A47 Wansford to Sutton Dualling

Volume 9 **9.11 Road Safety Audits**

Stage 1 Road Safety Audit

Road Safety Audit Response

Location: A1 Southbound (drawing: HE551494-GTY-HGN-000-DR-CH-30023)

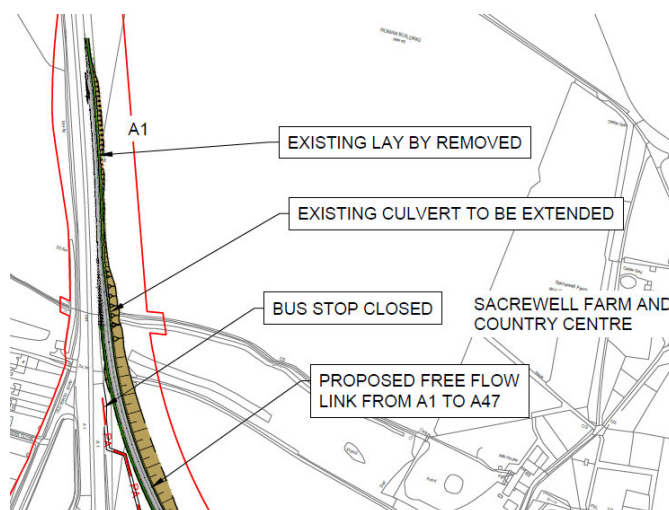
Summary: Removal of existing lay-by.

Description: An existing parking lay-by on the southbound carriageway of the A1 is to be removed as part of the new scheme. The removal of the lay-by will mean less opportunities for stopping safely on the A1. This may lead to inappropriate parking elsewhere on the road network and collisions between moving and parked vehicles, or drivers driving fatigued

Recommendation: Ensure the A1 southbound still has sufficient stopping facilities if the lay-by is removed.

Reference	RSA problem	RSA recommendation	Design organisation response	Overseeing Organisation response	Agreed RSA action
4.1. Geometry					
Problem 1	<p>Location: A1 Southbound (drawing: HE551494-GTY-HGN-000-DR-CH-30023)</p> <p>Summary: Removal of existing lay-by.</p> <p>Description: An existing parking lay-by on the southbound carriageway of the A1 is to be removed as part of the new scheme. The removal of the lay-by will mean less opportunities for stopping safely on the A1. This may lead to inappropriate parking elsewhere on the road network and collisions between moving and parked vehicles, or drivers driving fatigued</p>	<p>Ensure the A1 southbound still has sufficient stopping facilities if the lay-by is removed.</p>	<p>Disagree with problem: There is a lay-by approximately 1.3km north of the Wansford junction and HGV parking approximately 2km south of the scheme at Stibington.</p> <p>The inclusion of lay-bys in the vicinity of the junction diverges and merges creates a greater level of risk to road users from weaving movements than the increased spacing between rest places along the length of the A1 Trunk Road at this location.</p>	<p>Agree with Supplier:</p> <p>Evidence to be provided by supplier at detailed design stage to show removal of layby has no further adverse impacts on safety.</p> <p>Supplier to demonstrate this by providing risk assessment to support position.</p>	<p>Technical note (Appendix B) to be provided to support design position at detailed design phase to show removal of layby has no further adverse impacts on safety.</p>

Location: A1 / A47 junction, western roundabout. (Drawing: HE551494-GTY-HKF-000-DR-CH-30002).

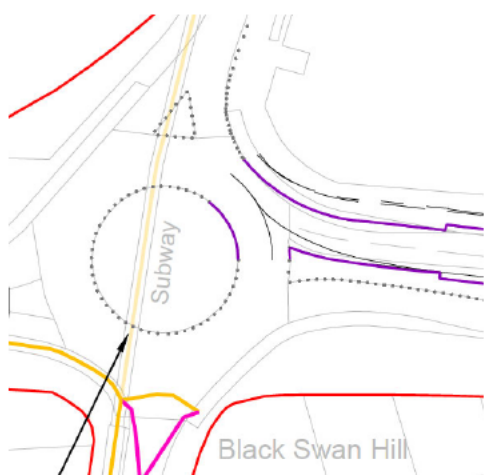
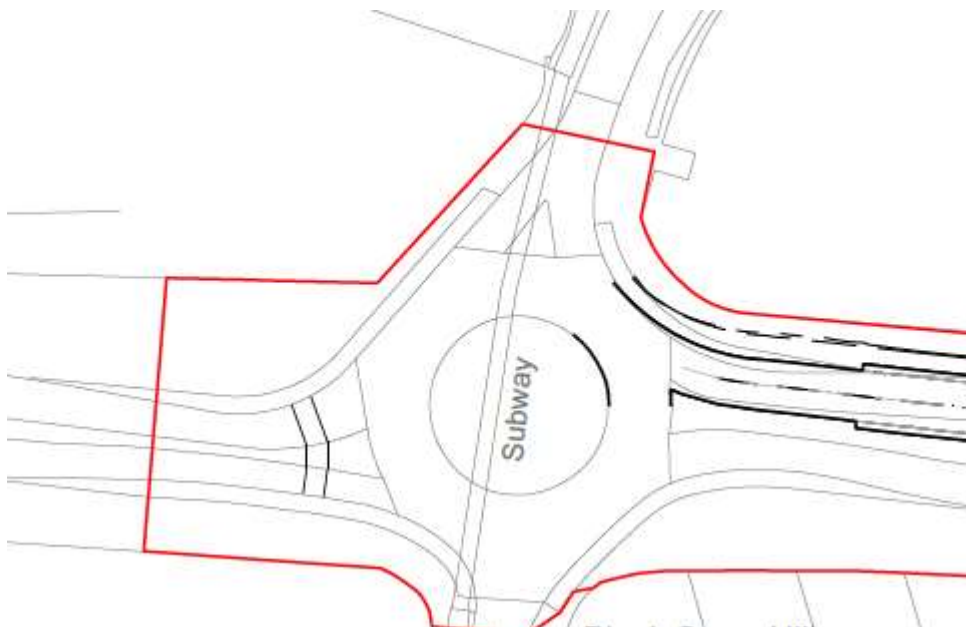
Summary: Narrow traffic lanes lead to side-swipe collisions.

Description: On the westbound approach to the western roundabout of the A1 / A47 junction there are currently two traffic lanes of narrow width. Larger vehicles were observed straying into the adjacent lane when entering the roundabout, with the risk of side-swipe collisions occurring. This existing situation is to be retained in the new scheme, meaning the potential risk of collisions will remain and potentially will be exacerbated by the dualling and driver 'expectation' to be able to travel side by side on a dual carriageway arrangement.

Recommendation: Re-design the westbound approach to the western roundabout with adequate lane widths.

Problem 2	<p>Location: A1 / A47 junction, western roundabout. (Drawing: HE551494-GTY-HKF-000-DR-CH-30002).</p> <p>Summary: Narrow traffic lanes lead to side-swipe collisions.</p> <p>Description: On the westbound approach to the western roundabout of the A1 / A47 junction there are currently two traffic lanes of narrow width. Larger vehicles were observed straying into the adjacent lane when entering the roundabout, with the risk of side-swipe collisions occurring. This existing situation is to be retained in the new scheme, meaning the potential risk of collisions will remain and potentially will be exacerbated by the dualling and driver 'expectation' to be able to travel side by side on a dual carriageway arrangement.</p>	<p>Re-design the westbound approach to the western roundabout with adequate lane widths.</p>	<p>Agree with the problem and disagree with recommendation.</p> <p>Any modification to the to the westbound approach to the western roundabout its outside of the project scope.</p> <p>In the latest design, the only change to the western roundabout is the upgrade to 2 lanes exit into the A47 eastbound in order to improve the traffic flows. This improved configuration will increase the deflection and induce larger vehicles to slow down on the approach to the roundabout and therefore decrease the probability of a sideswipe.</p> <p>The detailed design will show this with greater clarity.</p> <p>See Appendix - A Problem 2.</p>	<p>Agree with Supplier.</p>	<p>Western roundabout exit to A47 eastbound to be upgraded to 2 lanes exit with an increased deflection as shown in latest design. No further changes will be made to the western roundabout, as the western approach, is outside of the scope of the scheme.</p>

Only works proposed is to upgrade A47 EB to 2 lanes exit.

Location: A1 / A47 junction, western roundabout. (Drawing: HE551494-GTY-HKF-000-DR-CH-30002).

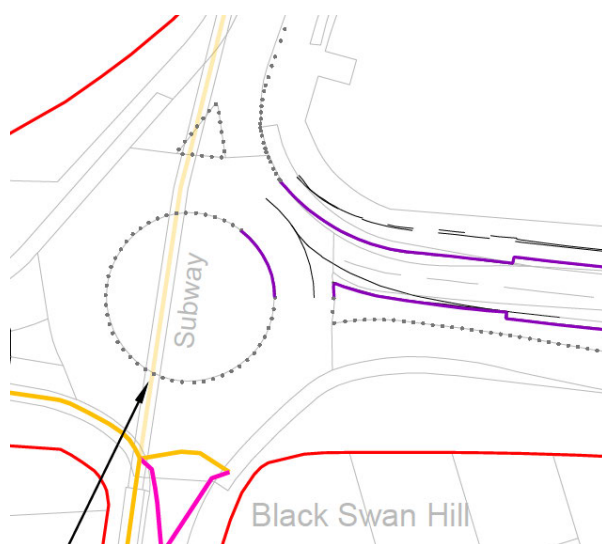
Summary: Widened carriageway leads to potential for side-swipe collisions.

Description: The eastbound A47 link between the two roundabouts of the A1/A47 junction will be widened to a full two traffic lanes from the point at which it leaves the western roundabout. This will be achieved by widening the existing carriageway on both sides. By widening the nearside kerb on the exit of what is a constrained roundabout the deflection offered by the circulatory carriageway will be reduced and two arms of the roundabout will be brought closer together. This may encourage some drivers to try to slip from the A1 arm to the A47 eastern arm without properly circulating around the roundabout, leading to side-swipe collisions.

Recommendation: Ensure that the new road layout maintains adequate circulatory carriageway on the western roundabout.

Problem 3	<p>Location: A1 / A47 junction, western roundabout. (Drawing: HE551494-GTY-HKF-000-DR-CH-30002).</p> <p>Summary: Widened carriageway leads to potential for side-swipe collisions.</p> <p>Description: The eastbound A47 link between the two roundabouts of the A1/A47 junction will be widened to a full two traffic lanes from the point at which it leaves the western roundabout. This will be achieved by widening the existing carriageway on both sides. By widening the nearside kerb on the exit of what is a constrained roundabout the deflection offered by the circulatory carriageway will be reduced and two arms of the roundabout will be brought closer together. This may encourage some drivers to try to slip from the A1 arm to the A47 eastern arm without properly circulating around the roundabout, leading to side-swipe collisions.</p>	<p>Ensure that the new road layout maintains adequate circulatory carriageway on the western roundabout.</p>	<p>Agree with problem and recommendation:</p> <p>Circulatory carriageway is 9m wide which is sufficient for max 2-lane entries. The existing circulatory carriageway is maintained and is not reduced. By providing 2 lanes of exit, we are allowing as smooth an exit path as possible from the roundabout given the physical constraints in the area. The road markings will provide the guidance on deflection to reduce the risk of side swipes occurring.</p> <p>The detailed design will show this with greater clarity.</p>	<p>Agree with Supplier</p>	<p>Design to show appropriate level of detail at detailed design to show that adequate deflection is present and the issue will be resolved at this stage.</p>

Location: Eastern A1/A47 roundabout (Drawing: HE551494-GTY-HKF-000-DR-CH-30003).

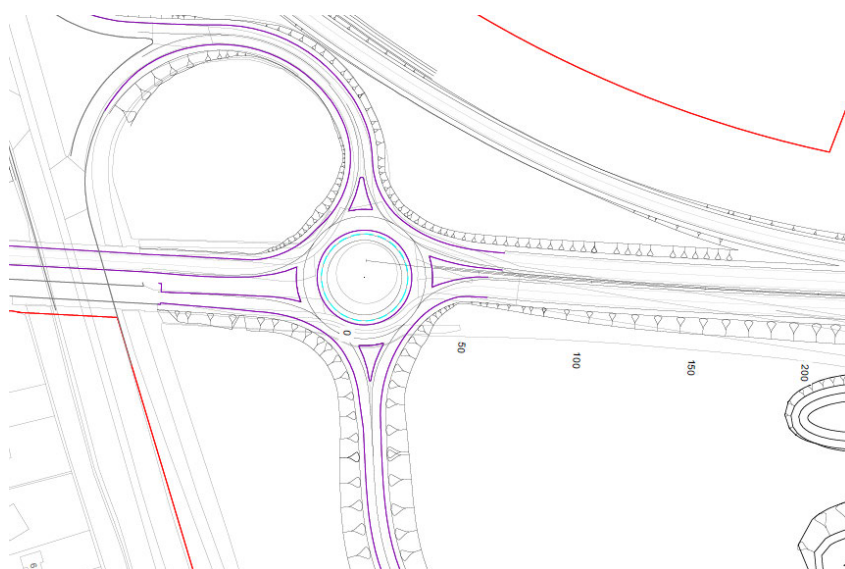
Summary: High vehicular speeds and lack of deflection leads to loss of control collisions.

Description: The re-designed eastern A1/A47 roundabout will be located at the end of a significant section of national speed limit dual carriageway. High vehicle approach speeds are likely on the westbound A47 approach to the roundabout. The road alignment provides virtually no deflection through the roundabout and this could lead to vehicles entering the roundabout at inappropriate speeds and loss of control / overshoot collisions

Recommendation: Design the roundabout and approach alignments such that adequate deflection is introduced that encourages slower speeds through the roundabout. For consistency it is recommended that yellow bar markings be provided on this westbound approach to the roundabout junction.

Problem 4	<p>Location: Eastern A1/A47 roundabout (Drawing: HE551494-GTY-HKF-000-DR-CH-30003).</p> <p>Summary: High vehicular speeds and lack of deflection leads to loss of control collisions.</p> <p>Description: The re-designed eastern A1/A47 roundabout will be located at the end of a significant section of national speed limit dual carriageway. High vehicle approach speeds are likely on the westbound A47 approach to the roundabout. The road alignment provides virtually no deflection through the roundabout and this could lead to vehicles entering the roundabout at inappropriate speeds and loss of control / overshoot collisions</p>	<p>Design the roundabout and approach alignments such that adequate deflection is introduced that encourages slower speeds through the roundabout. For consistency it is recommended that yellow bar markings be provided on this westbound approach to the roundabout junction.</p>	<p>Agree with problem and recommendation of adequate deflections.</p> <p>Disagree with recommendation for yellow bar markings.</p> <p>Deflection:</p> <p>All entries are designed with a 7.5m offset to the centre of the roundabout, such that deflection is increased and vehicles exiting the roundabout have a smooth exit. Entry angles from the north arm clockwise are as follows: 17.0°, 30.4°, 30.9°, 30.7°. Therefore, the proposed design has an appropriate deflection.</p> <p>Yellow bar markings:</p> <p>The distance of the dual carriageway is not what would be considered significant at about 2km on a rising gradient towards the Wansford eastern roundabout.</p>	<p>Agree with Supplier - Yellow bar markings not to be incorporated on A1/A47 eastern roundabout westbound approach as per Traffic Signs Manual Chapter 5 para 6.10.3. The distance between the junction will be less than 3km.</p>	<p>Detailed design to show roundabout approach alignments with adequate deflection.</p> <p>Yellow bar markings not to be incorporated on A1/A47 eastern roundabout westbound approach as per Traffic Signs Manual Chapter 5 para 6.10.3. The distance between the junction will be less than 3km.</p>

Reference	RSA problem	RSA recommendation	Design organisation response	Overseeing Organisation response	Agreed RSA action
			<p>The problem identified is accepted and will be mitigated with advanced warning signs and advanced direction signs that have been designed to give clear and concise information relating to the road layout ahead.</p> <p>The yellow bar markings used on the eastbound approach to the Sutton roundabout are provided as this roundabout is the first at-grade junction whereby A47 dual carriageway users will require to give way for approximately 12km. It is not considered that the short 2km section prior to Wansford is not consistent for use of this marking.</p> <p>Chapter 5 of the Traffic Signs Manual advises that yellow bar markings are not to be used when the distance between junctions is less than 3km. Overuse of the marking may reduce its effectiveness at higher risk locations.</p>

Location: New link to Sacrewell Farm (Drawing: HE551494-GTY-HGN-000-DR-CH-30017).

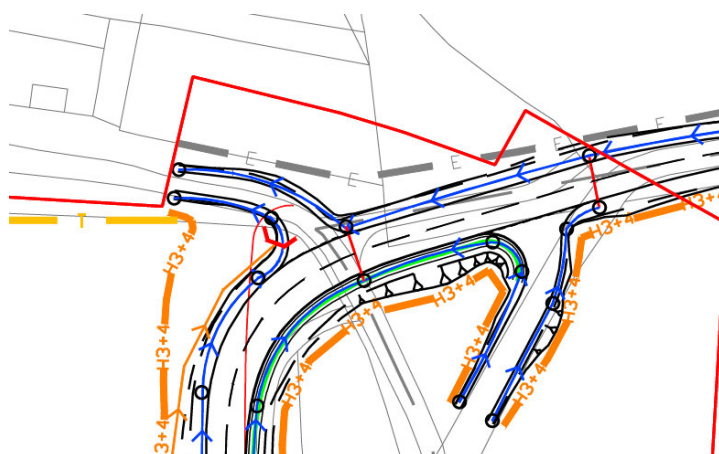
Summary: Limited intervisibility leading to vehicles turning out of side road colliding with vehicles on the new link road.

Description: Two side roads are proposed on the new link to Sacrewell Farm, immediately adjacent to a sharp bend in the road. Vehicles traversing the new road may strike vehicles turning out of the side roads if they are not expecting them after the bend.

Recommendation: Ensure the road layout provides drivers with full appreciation of upcoming hazards and enough visibility and time to react.

Problem 5	<p>Location: New link to Sacrewell Farm (Drawing: HE551494-GTY-HGN-000-DR-CH-30017).</p> <p>Summary: Limited intervisibility leading to vehicles turning out of side road colliding with vehicles on the new link road.</p> <p>Description: Two side roads are proposed on the new link to Sacrewell Farm, immediately adjacent to a sharp bend in the road. Vehicles traversing the new road may strike vehicles turning out of the side roads if they are not expecting them after the bend.</p>	Ensure the road layout provides drivers with full appreciation of upcoming hazards and enough visibility and time to react.	<p>Agree with Problem and Recommendation:</p> <p>The latest design includes extensive input from consultation with stakeholders representing Sacrewell Farm, who are the beneficiaries of one of the side roads. Signage will be provided to alert road users to the upcoming junctions. The second side road is likely to incur no public use, with only the private landowner needing access, limiting the safety risk. For the vehicles leaving the side roads to join the main road, convex mirror(s) can be provided to increase visibility- any such design details to be provided at SGAR 5.</p>	Agree with Supplier	Convex mirrors to be provided to be to increase visibility and will be incorporated into detailed design ahead of SGAR 5.

Location: Petrol filling station on A47 mainline (Drawing: HE551494-GTY-HGN-000-DR-CH-30017).

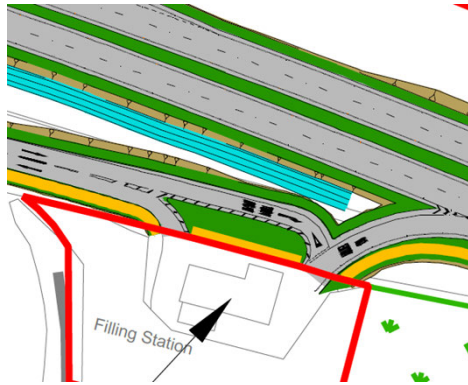
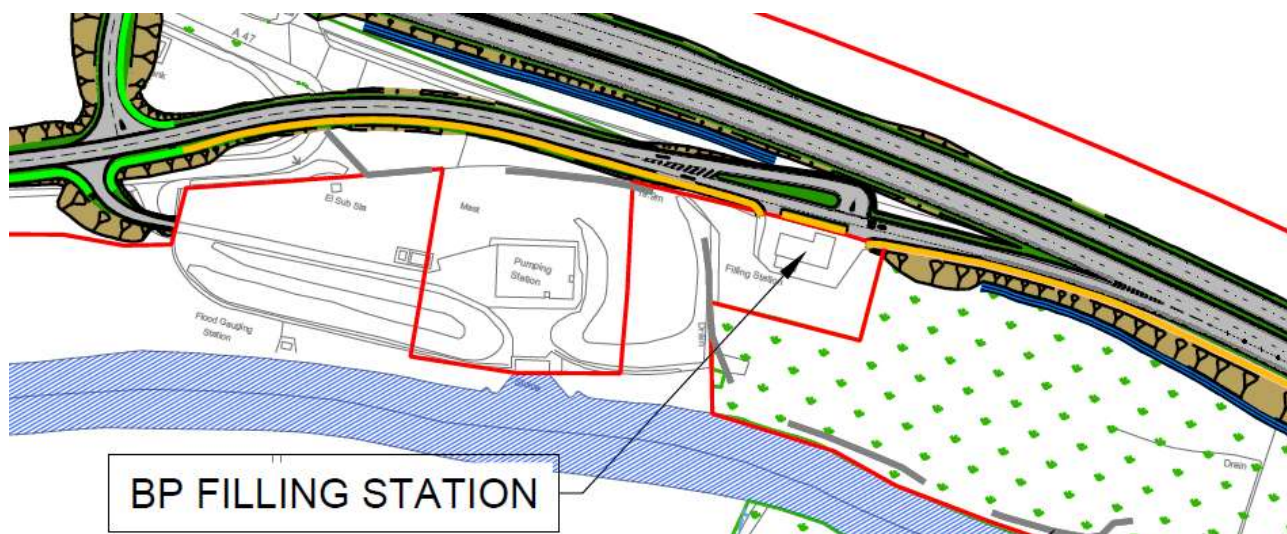
Summary: Vehicle conflicts within the filling station forecourt.

Description: The existing filling station is to be provided with access from the westbound A47 carriageway and a new two-way link road. The eastern end of the new link road is not provided with a turning area, with the filling station forecourt apparently to be used for turning. The existing forecourt was observed to be constrained in space, with little room for vehicles to manoeuvre around vehicles stationed at the filling pumps. It is also noted that there is no route available around the rear of the petrol station building, as it appears the building has been extended to afford more shop/storage space.

Problem 6	<p>Location: Petrol filling station on A47 mainline (Drawing: HE551494-GTY-HGN-000-DR-CH-30017).</p> <p>Summary: Vehicle conflicts within the filling station forecourt.</p> <p>Description: The existing filling station is to be provided with access from the westbound A47 carriageway and a new two-way link road. The eastern end of the new link road is not provided with a turning area, with the filling station forecourt apparently to be used for turning. The existing forecourt was observed to be constrained in space, with little room for vehicles to manoeuvre around vehicles stationed at the filling pumps. It is also noted that there is no route available around the rear of the petrol station building, as it appears the building has been extended to afford more shop/storage space.</p> <p>The proposed road layout around the filling station could lead to vehicles becoming stuck on the link road, or backing up onto the A47 mainline, if the filling station forecourt is full, with the potential for dangerous manoeuvres and vehicle to vehicle collisions.</p> <p>Additionally, some drivers travelling westbound on the A47 may try to use the filling station forecourt as a short-cut to the new link road, increasing the risk of conflicts.</p>	Design the road layout such that it is not reliant on the filling station forecourt forming part of the network.	<p>Agree with Problem and Recommendation:</p> <p>The layout at the filling station is being altered to provide a through route past it – roughly on the alignment of the existing A47. The Filling station will be offset as per the current layout with clear signing to prohibit movements onto the A47 against the flow of traffic.</p> <p>In the new design, vehicles travelling EB will be able to turn WB is the filling station is closed. Also, vehicles coming from A47 WB will be able to continue WB through the new link if the petrol station is closed.</p> <p>Please See Appendix - A Problem 6.</p>	Agree with Supplier – the design has been modified to solve the problem.	The design has been altered to solve all the issues raised in this observation.

Location: New Nene Way Roundabout (drawing: HE551494-GTY-HGN-000-DR-CH-30020).

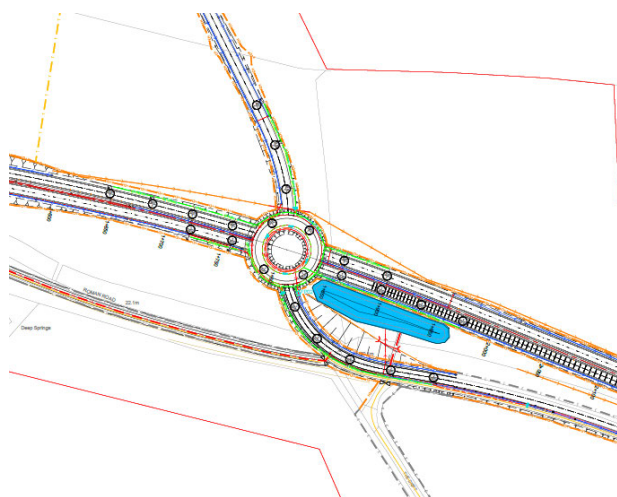
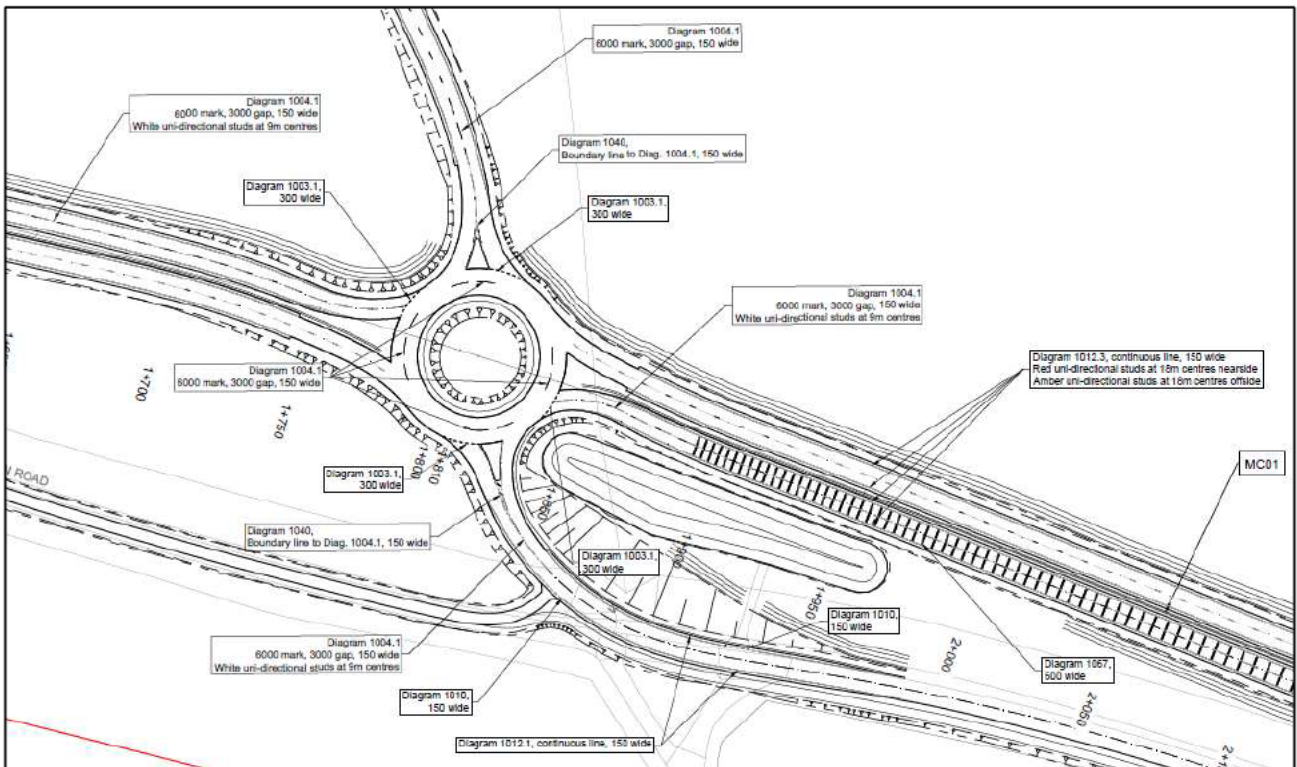
Summary: High vehicular speeds and lack of deflection leads to loss of control collisions.

Problem 7	<p>Location: New Nene Way Roundabout (drawing: HE551494-GTY-HGN-000-DR-CH-30020).</p> <p>Summary: High vehicular speeds and lack of deflection leads to loss of control collisions.</p> <p>Description: The new Nene Way roundabout will be located on national speed limit dual carriageway, with high vehicle speeds likely on both mainline approaches to it. The road alignment provides virtually no deflection through the roundabout and this could lead to vehicles entering the roundabout at inappropriate speeds and loss of control collisions.</p> <p>It is appreciated that transverse yellow road markings are proposed on the westbound approach, but this may not be sufficient to reduce westbound approach speeds and does not help eastbound speeds.</p>	Design the roundabout and A47 approach alignments such that adequate deflection is introduced that encourages slower speeds through the roundabout. For consistency, it is recommended that yellow bar markings be provided on the eastbound approach to the roundabout junction also.	<p>Agree with the problem and recommendation of adequate deflection.</p> <p>Disagree with recommendation for yellow bar markings:</p> <p>General:</p> <p>The problems identified are accepted and will be mitigated with advanced warning signs and advanced direction signs that have been designed to give clear and concise information relating to the road layout ahead.</p> <p>Deflection:</p> <p>7.5m offset from centre deflection is provided for all arms, providing ease of exit from roundabout while strongly encouraging entering roundabout to slow down. Design has been updated- was not modelled at the time pending</p>	Agree with Supplier - Yellow bar markings not to be incorporated on A1/A47 eastern roundabout westbound approach as per Traffic Signs Manual Chapter 5 para 6.10.3. The distance between the junction will be less than 3km.	<p>Detailed design to show roundabout approach alignments with adequate deflection.</p> <p>Yellow bar markings not to be incorporated on A1/A47 eastern roundabout westbound approach as per Traffic Signs Manual Chapter 5 para 6.10.3. The distance between the junction will be less than 3km.</p>

Reference	RSA problem	RSA recommendation	Design organisation response	Overseeing Organisation response	Agreed RSA action
			<p>traffic data from traffic team. Design fix C provides appropriate deflection.</p> <p>Yellow bars:</p> <p>There are proposed yellow bar markings used on the west approach to the Sutton roundabout as this roundabout is the first at-grade junction whereby A47 dual carriageway users will require to give way for approximately 12km. It is not considered to proposed yellow bar making in the east approach to this roundabout as there is only 2km section to the next roundabout prior to Wansford and this is not consistent for use of this marking.</p> <p>Chapter 5 of the Traffic Signs Manual advises that yellow bar markings are not to be used when the distance between junctions is less than 3km. Overuse of the marking may reduce its effectiveness at higher risk locations.</p> <p>See Appendix - A Problem 7.</p>

Updated scheme design fix C.

Location: Junction of Sutton Heath Road and Langley Bush Road.
(Drawing; HE551494-GTY-HMK-000-DR-CH-30005).

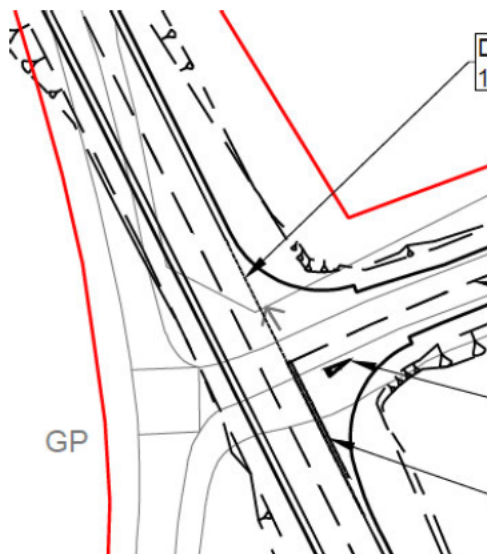
Summary: Large vehicles over run grass verges, leading to loss of control.

Description: The existing Sutton Heath Road / Langley Bush Road junction is to be realigned as a new, simple priority junction. Verge damage was observed at the existing priority junction (see photo below), suggesting that large vehicles struggle to negotiate the junction. This may continue in the future scenario with the risk of loss of control collisions.

Recommendation: Ensure that the realigned priority junction can accommodate all vehicles expected to use it.

Problem 9	<p>Location: Junction of Sutton Heath Road and Langley Bush Road. (Drawing: HE551494-GTY-HMK-000-DR-CH-30005).</p> <p>Summary: Large vehicles over run grass verges, leading to loss of control.</p> <p>Description: The existing Sutton Heath Road / Langley Bush Road junction is to be realigned as a new, simple priority junction. Verge damage was observed at the existing priority junction (see photo below), suggesting that large vehicles struggle to negotiate the junction. This may continue in the future scenario with the risk of loss of control collisions.</p> <p>Recommendation: Ensure that the realigned priority junction can accommodate all vehicles expected to use it.</p>	<p>Ensure that the realigned priority junction can accommodate all vehicles expected to use it.</p>	<p>Agree with Problem and Recommendation:</p> <p>Junction layout provides tapers and radii appropriate for large vehicles in rural location, as defined in DMRB. Any further increases required to this provision will be checked with vehicle tracking software during SGAR 5.</p>	Agree with Supplier	Junction tapers and radii to be checked again during detailed design to ensure they meet the latest DMRB standard.
